**PLANNING COMMISSION CONDITIONAL USE SITE PLAN  
REVIEW SHEET**

**CASE NUMBER:** SPC-2021-0284C

**PROJECT NAME:** St. Elmo Service Center

**CITY OF AUSTIN – DEVELOPMENT SERVICES DEPARTMENT  
SITE PLAN APPLICATION – MASTER COMMENT REPORT**

**SP1**

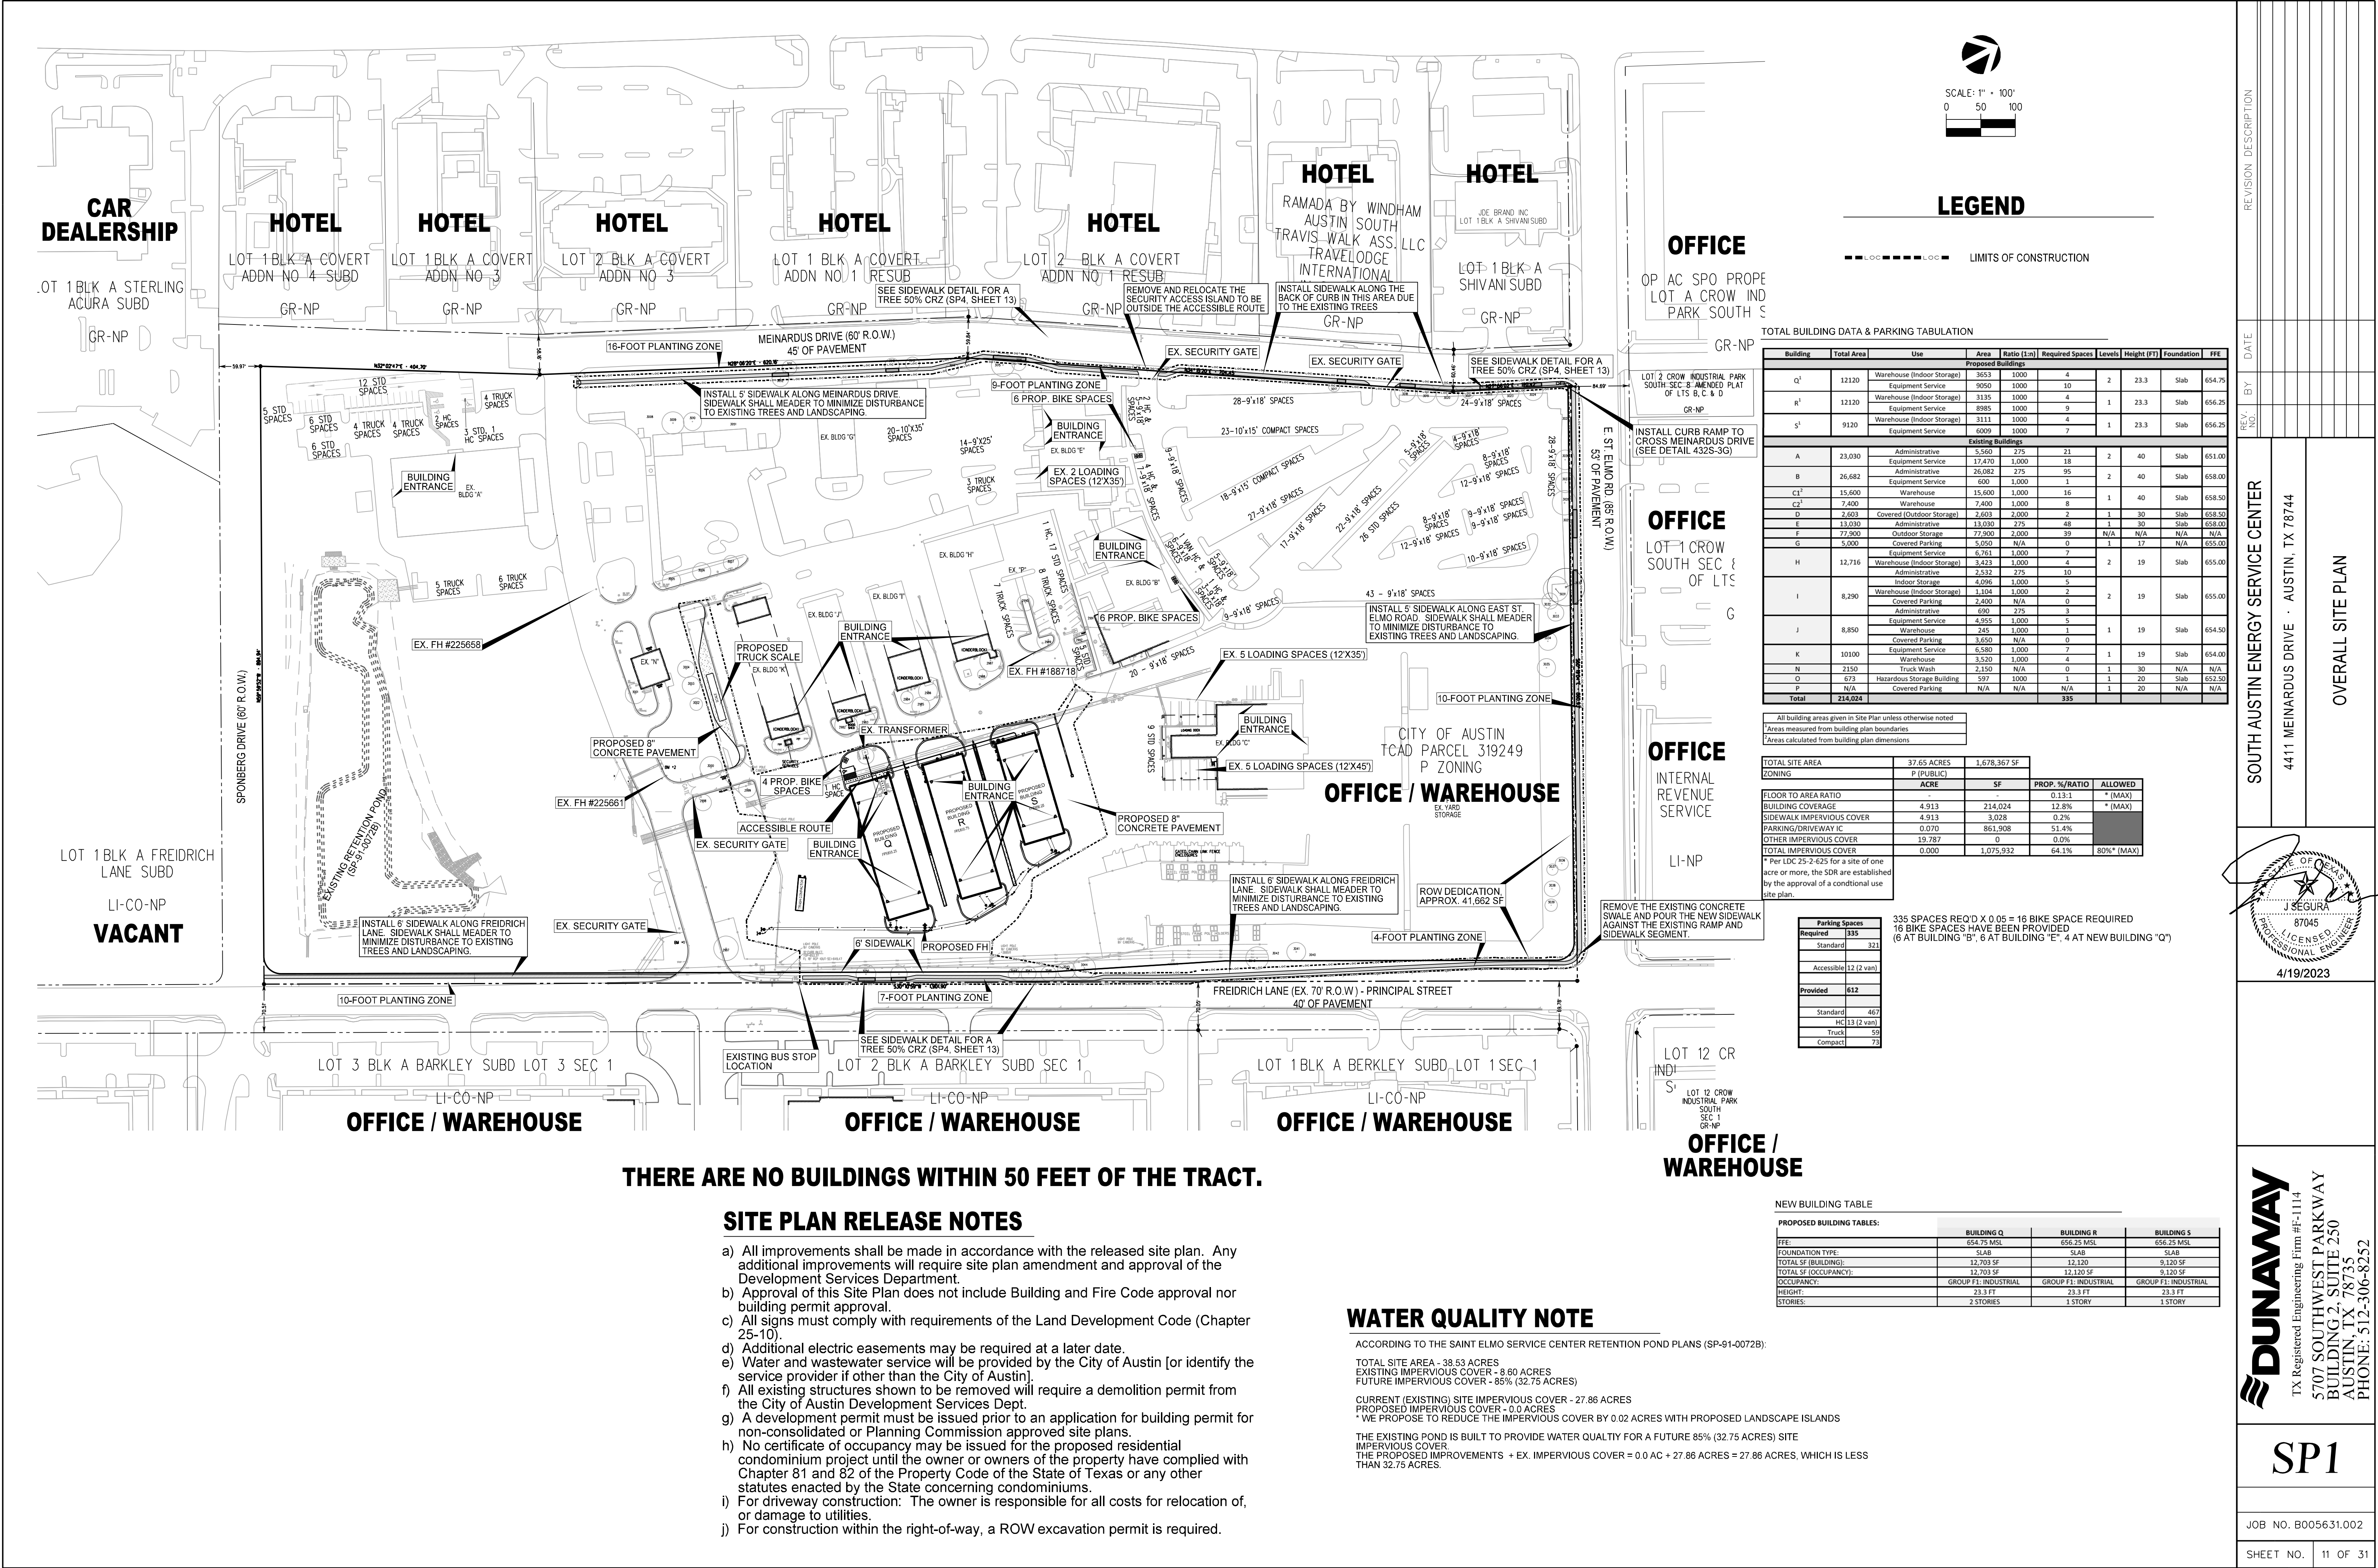
SP 1. Show the following site information (show proposed and allowed) in a Site Data Table:

U1: Comment remains; Please add 'allowed' and 'proposed'. See example below. Also please use similar formatting, font size, and font type for all tables on the site plan sheet so that it's easier to read. Also please remove GIS photo so that site plan is easier to read.

U2: Comment partially cleared. Shouldn't this be 25.75 per sheet 9?

FYI: The new building table in the bottom right corner of the site plan sheet is redundant given the same info is listed in the building data and parking tabulation table above.

SP10. Show the following site plan release notes on the site plan:

**U1-3: Repeat note: Comment cleared; please note that you have these notes on both the cover page and site plan sheet, you only need them in one place. And you can remove the note re condos but please include all the other notes listed above.**

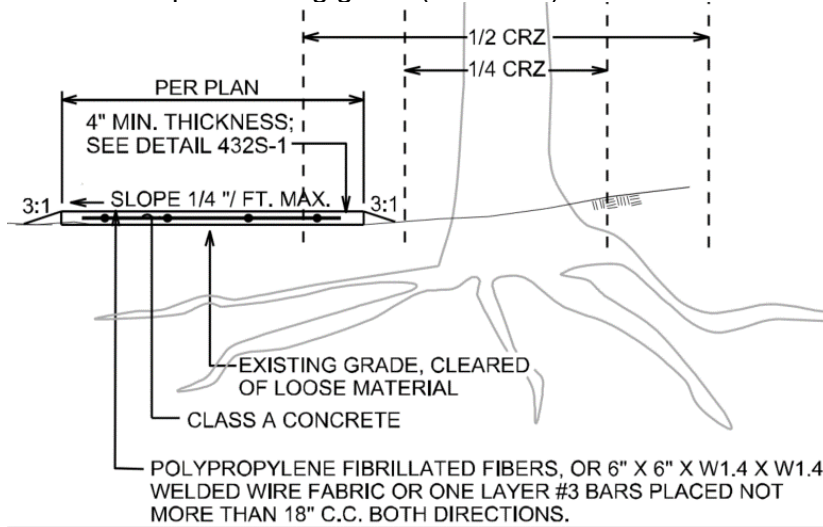
CA 1. U0: The proposed trail/walkway along Friedrich Ln does not meet minimum preservation criteria for trees #3049 and #3050. Please provide mitigation for these trees. See mitigation comment and preservation comment for more information.

U1: Plans were submitted with details for specially constructed sidewalks within the CRZ's of trees. Please update the details to show the thickness of the concrete in the detail. Please provide callouts, or provide a unique graphic, on the Erosion & Sedimentation Control Plan and

Site Plan showing where the alternate sidewalk construction method will be used. Further review pending.

U2: The proposed sidewalk does not meet preservation criteria for trees #3012, 3016, #3018, #3022, #3024, #3030, and #3052, as the sidewalk impacts their Quarter CRZs.

Please remove sidewalk from within their Quarter CRZs or provide mitigation.

**U3: Comment pending.** Trees #3015, #3016, #3018, #3020, #3022, #3024, and #3030 do not meet preservation criteria, as the modified sidewalk detail provided on sheet 13 shows fill greater than 4" on top of existing grade (Half CRZ):
